Office Action Summary	Application No. 10/585,890	Applicant(s) TATESON, JANE E.	
	Examiner SUJOY K. KUNDU	Art Unit 2863

DETAILED ACTION

FIG. 2

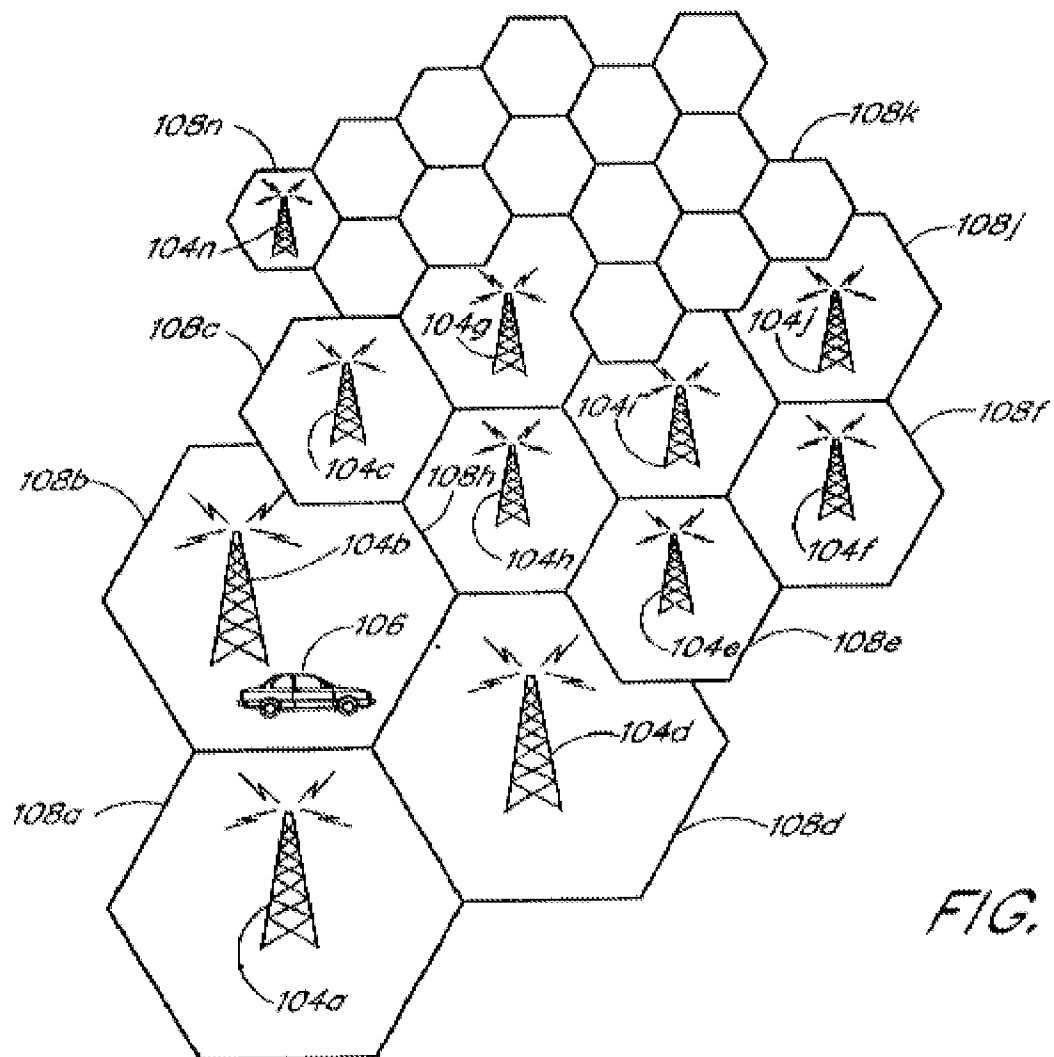
In the Non-Final Action dated October 16, 2008, the examiner specifically refers to Page 4, Paragraph 55 (Page 4 of Non-Final), Wan uses the language, “the mobile unit 106 may determine the speed or the rate of change of the received signal strength...” The applicant does not specify what values of the property are in the claim language. The examiner has interpreted the speed or the rate of change of the received signal strength as a property. Additionally, Figure 2 shows multiple base stations in neighboring cells, which the signal strength is measured, therefore the multiple base stations are interpreted as similar devices.
